**TOWN OF WATERFORD, CT
PLANNING & DEVELOPMENT**

**Re: Application #C 24-08 – 234 Bloomingdale Road
Application Review Comments**

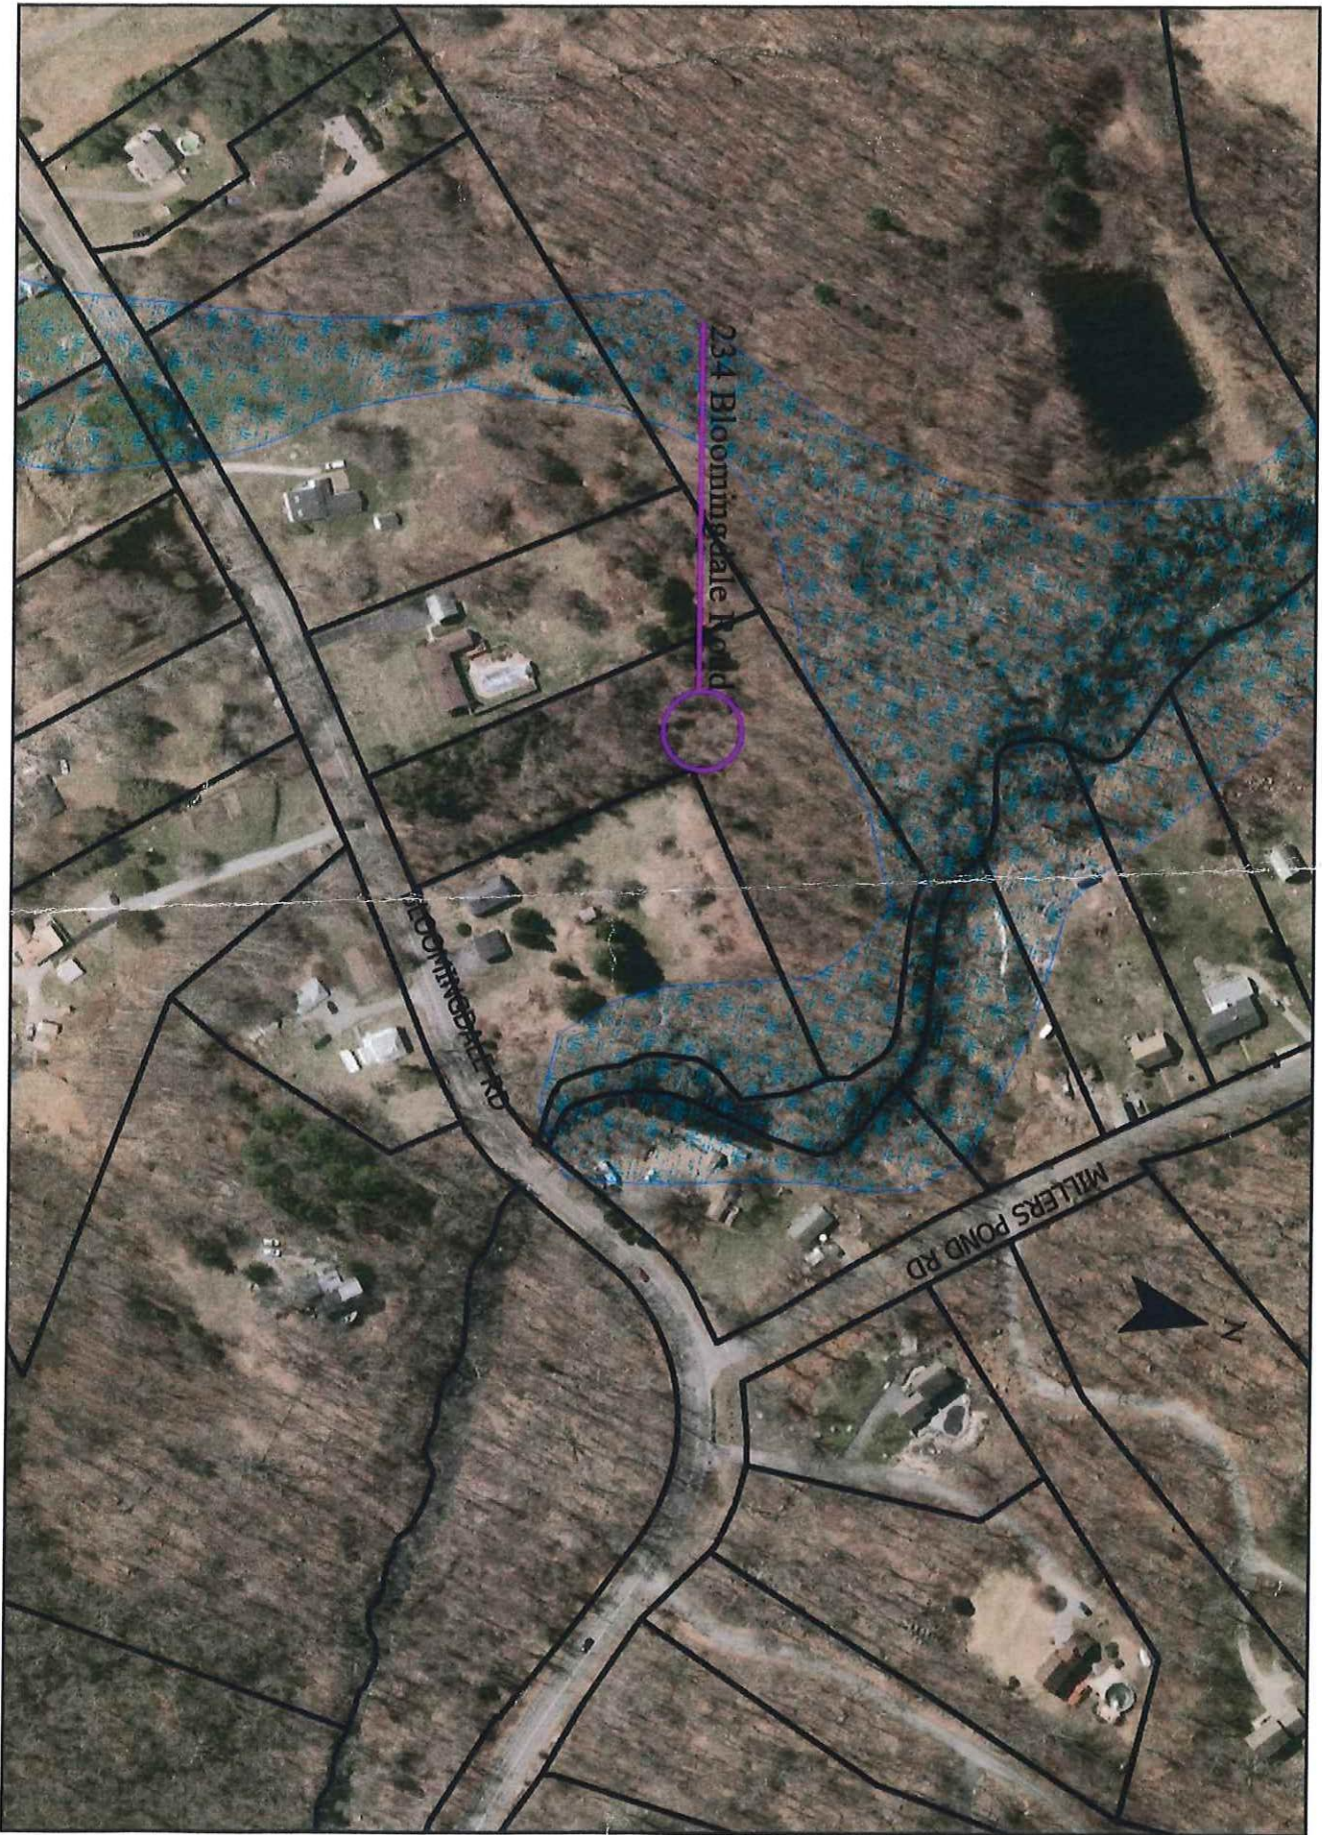
1. The wetland delineation report (Sept. 25, 2024) does not include the date of the site plan showing the delineated wetland boundary and proposed development.
2. The discussion of the soil units in the report does not agree with the soil map and Table 1 soil types. The Rippowam soil is the poorly drained soil associated with wetland #3. The well-drained Agawam soil is associated with the proposed are of residential development.

3. The referenced rationale list for the Corps wetland functions/values evaluation form was not included in appendix D.
4. The proposed limits of permanent clearing and disturbance should be included on the plan.

5. Measures to provide long-term vegetative buffers to the isolated wetlands and the riparian wetland along Hunts Brook should be considered. Maintenance of a vegetated buffer adjacent to the wetland boundary would serve to filter surface run-off, stabilize soils, provide habitat connectivity and protect the potential vernal pool habitat.

6. The application should address the potential impact to the vernal pool habitat associated with the development area and loss of upland woodland adjacent to wetland #1. The report indicates the installation of proper erosion controls would mitigate the potential impact to wildlife habitat from the proposed regulated activity. Protection of adjacent upland area would help in preserving the possible unique wildlife habitat value.

7. The report recommends that wetland #1 be cleared of debris and restored to an "original condition". Additional description of the work associated with this activity should be provided as this involves excavation within a wetland. The glass, metal and debris continues below the surface layer of this wetland. What are the proposed restoration measures (depth of excavation, restoration of surface soil layer, planting, etc.). The site plan will need to include the location of stockpiles, equipment and any associated clearing around the wetland perimeter.
